Title: Bluetooth Portable iP67 Color Changing Speaker

Version: 5

Model #: iBT374

Date: 11.29.2016

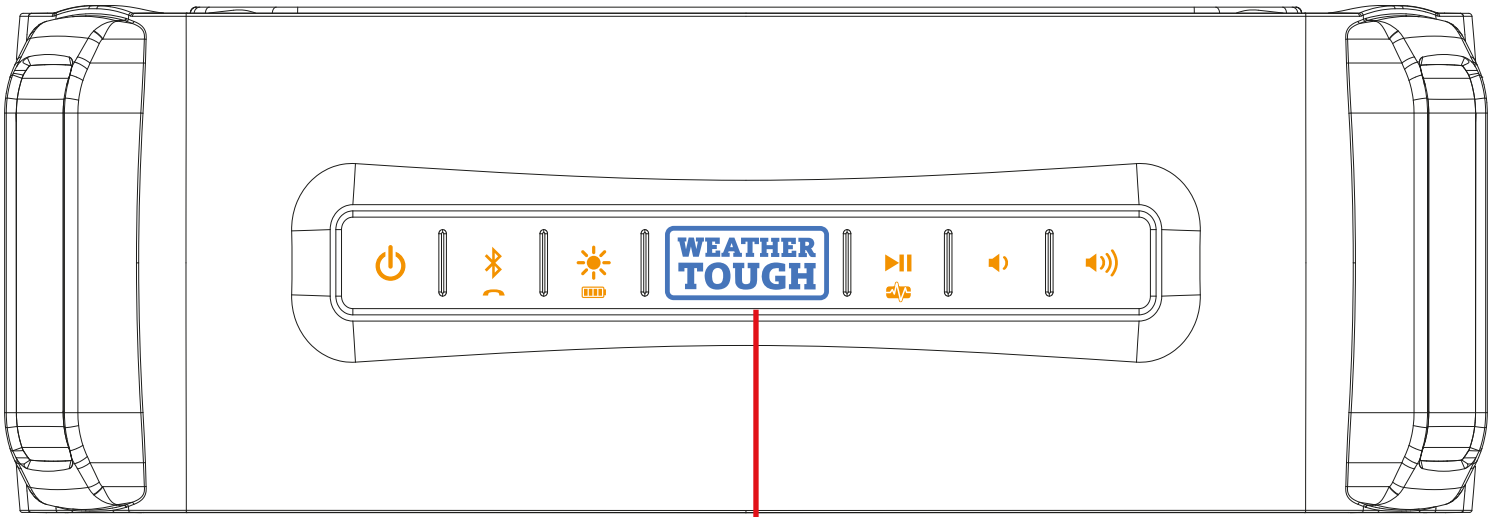
add the voice icon  
Dec. 01, .2016

debossed - .2mm  
glossy finish, ref. iBT82

increased size of  
Weather Tough  
logo 10.31.2016

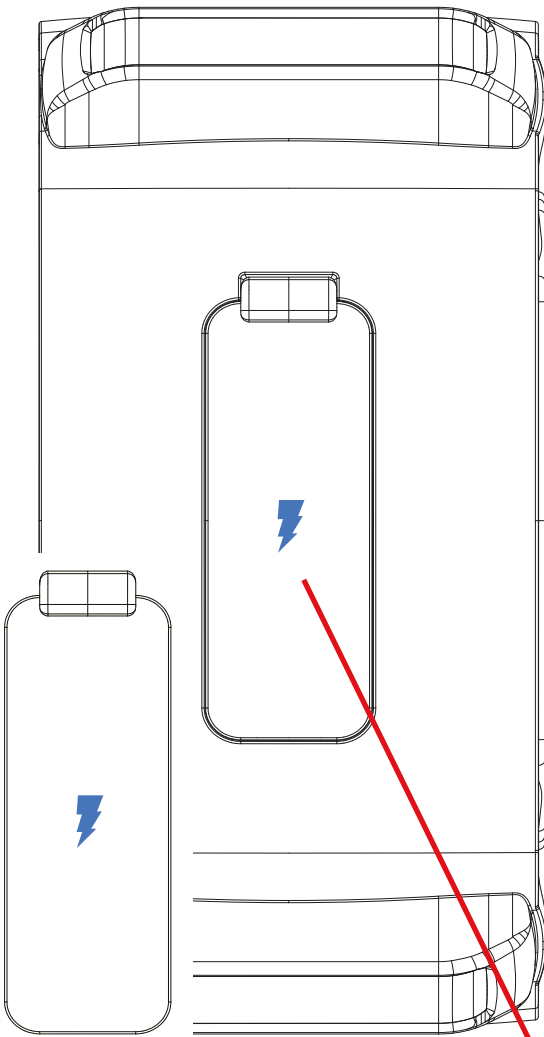
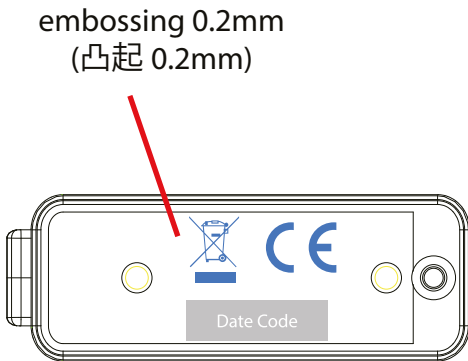
iHome Badge - Coined Aluminum, match HWL83 badge

debossed - .2mm  
glossy finish, ref. iBT82

embossing 0.2mm  
(凸起 0.2mm)

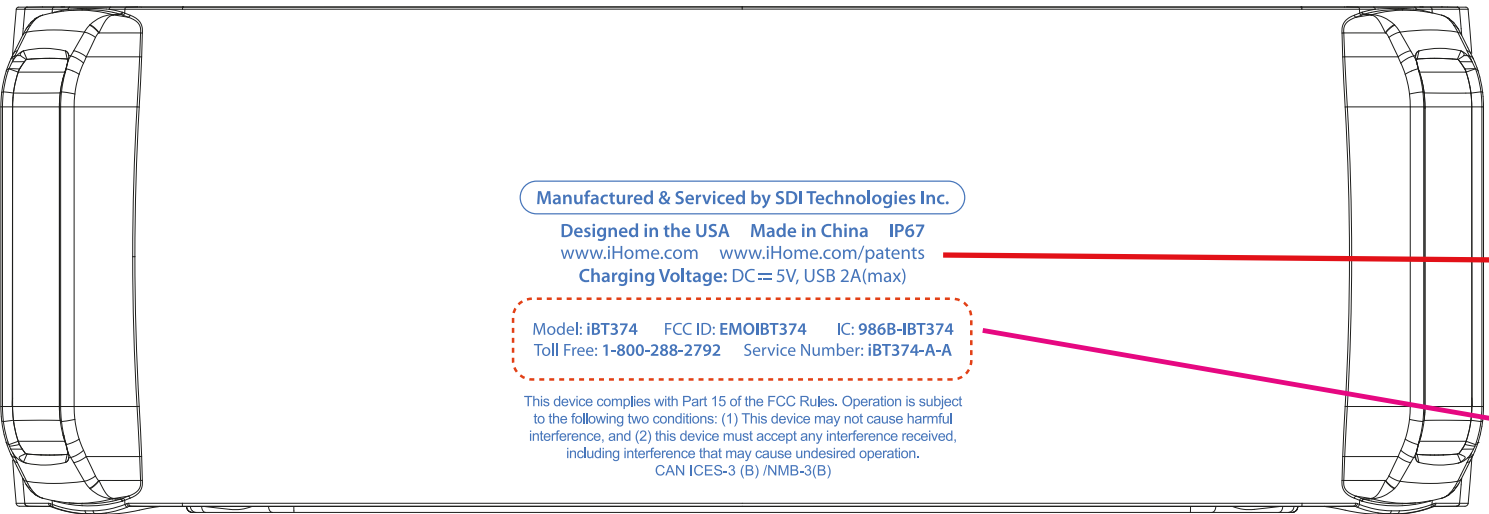
door underside  
added 10.31.2016

Model Plate Info  
debossed - .2mm  
glossy finish,  
ref. iBT82 model plate

UPDATED 10.31.2016  
Scaled up text size  
Increased size of interchangeable plate
